SUBJECT: Response to City Geotechnical Review for MA22123, Proposed New Warehouse/Retail Facility, Riverside Drive (APN 156-030-016, -017 and -042), City of Jurupa Valley, California

Introduction/Items Response

As requested, we have prepared the following response to the subject review comments dated April 7, 2023.

PLOT TIME: 5/9/2023 9:15 AM

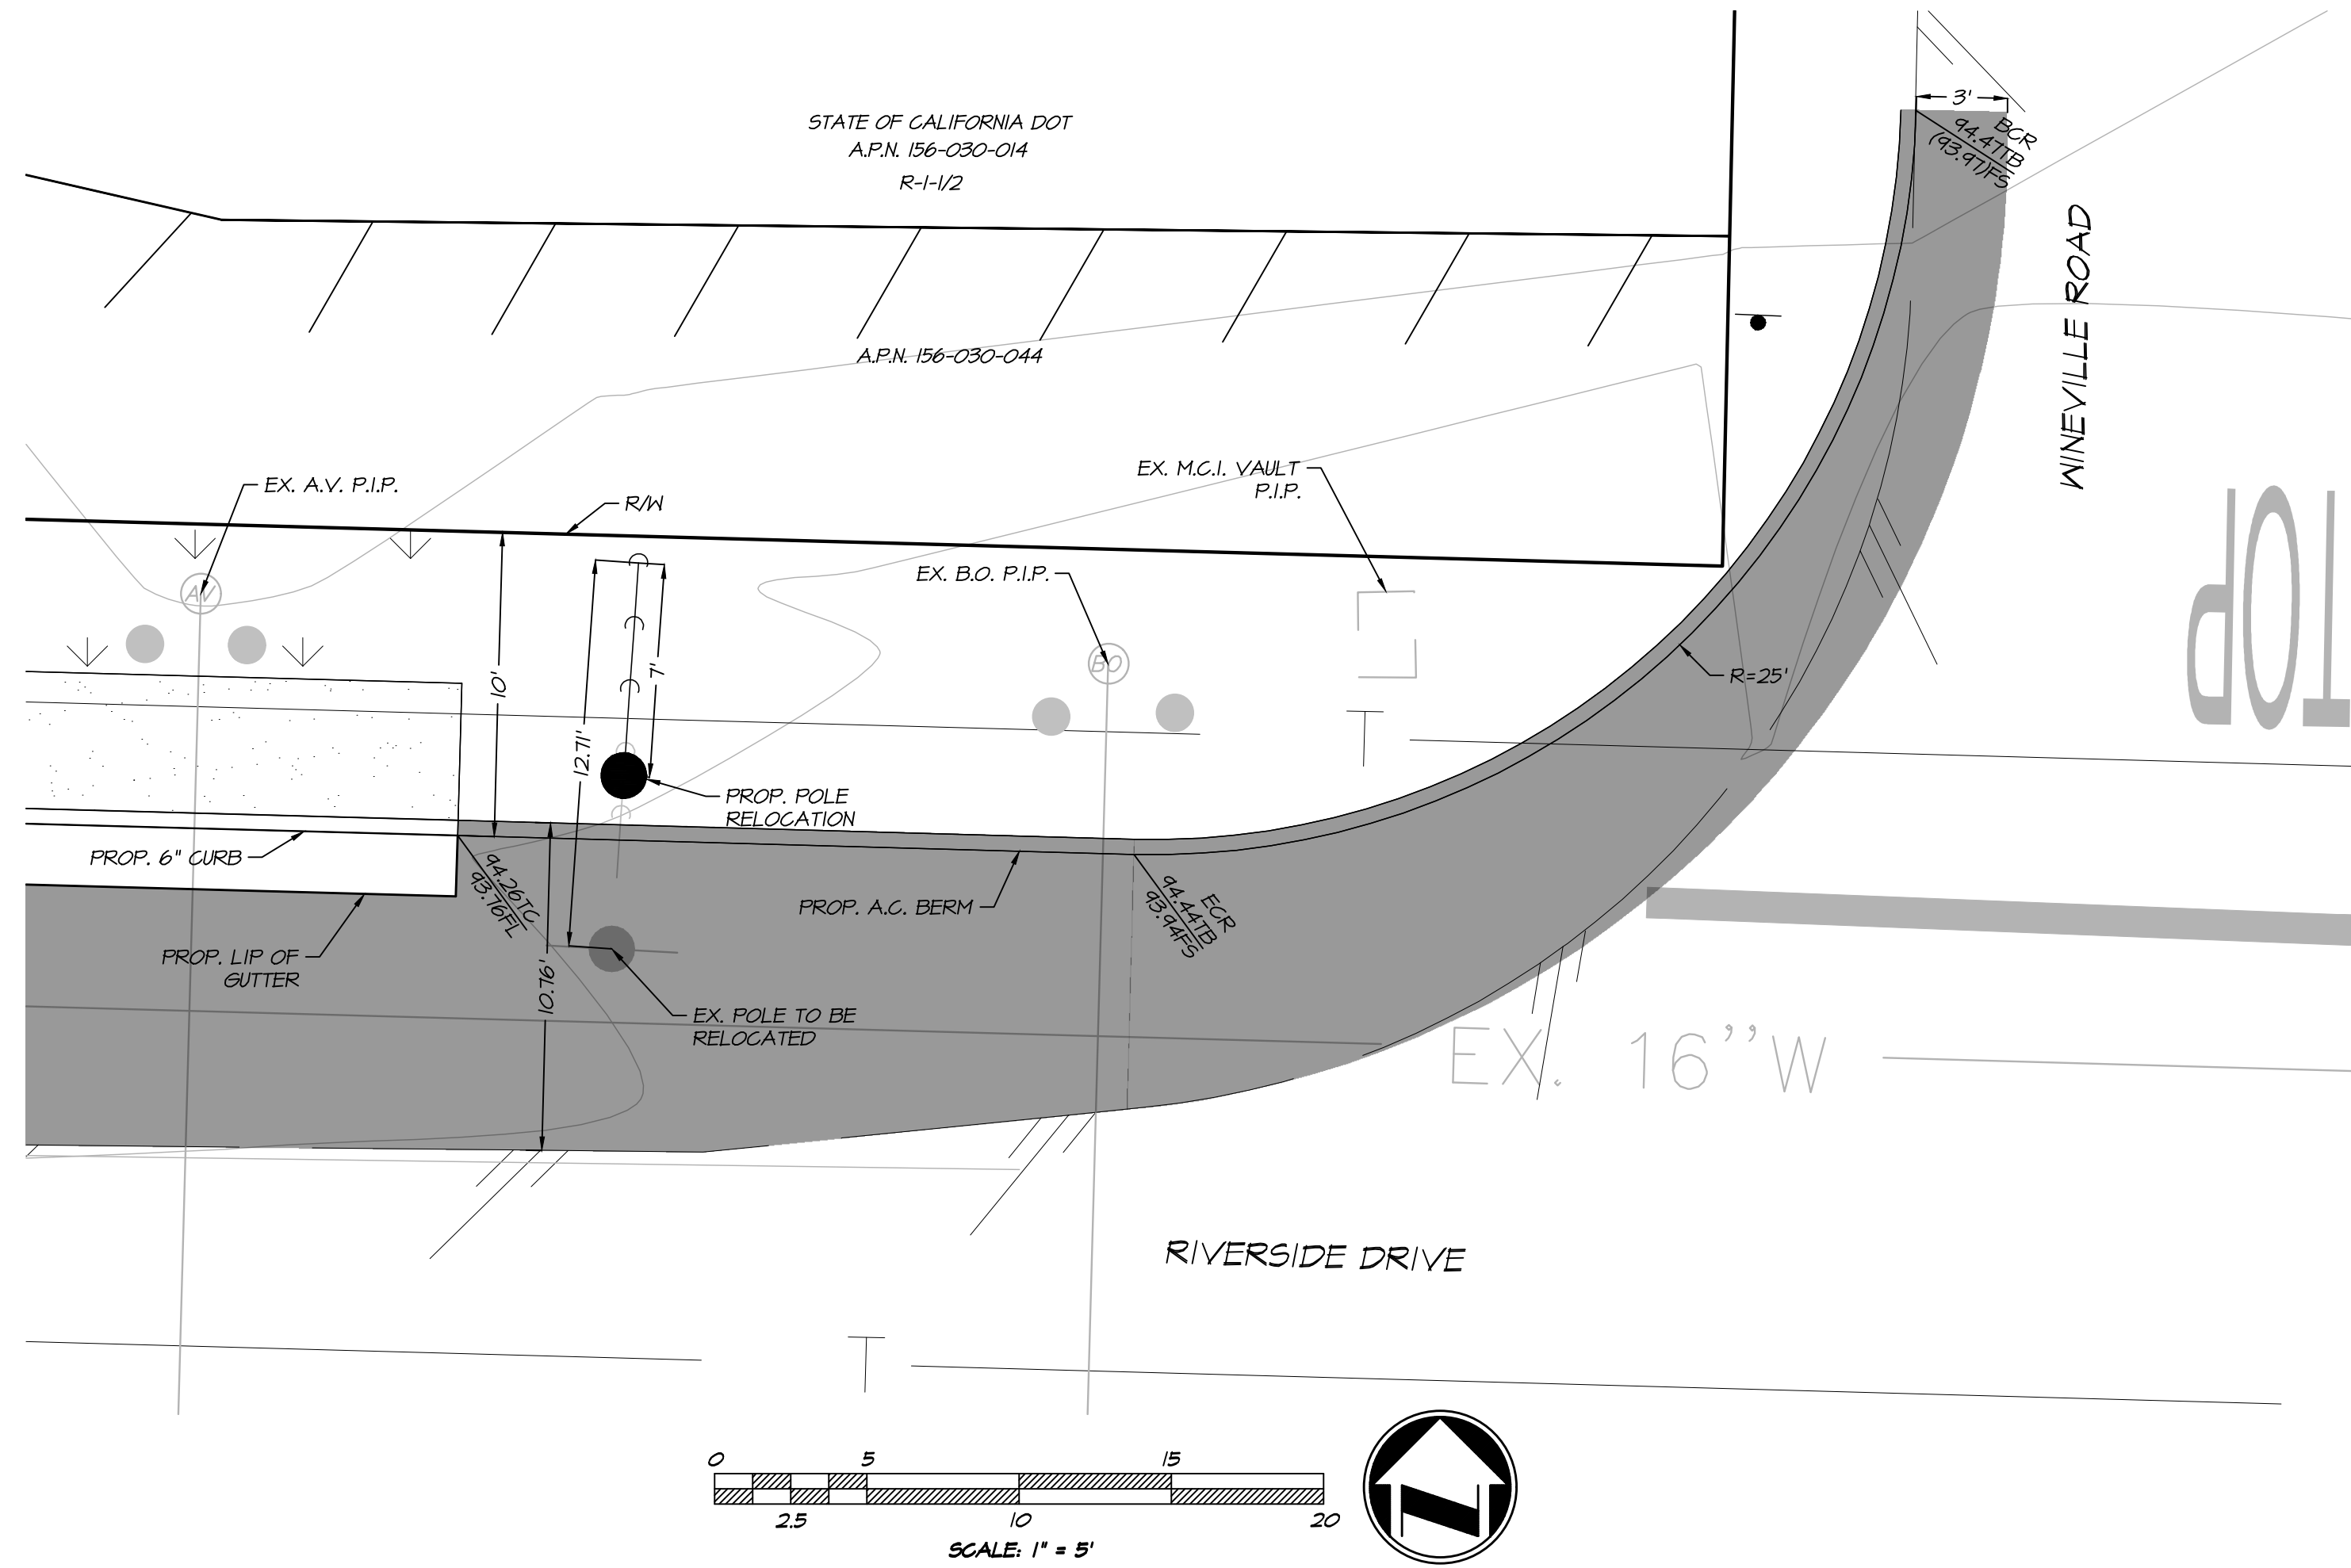
Comment No. 8: The conceptual grading plans that were submitted to the City were reviewed and the future precise grading plans and foundation plans will be reviewed for conformance with the report. Rodriguez consulting and Engineering should review any changes in the project and modify and approve in writing the conclusions and recommendations of this report.
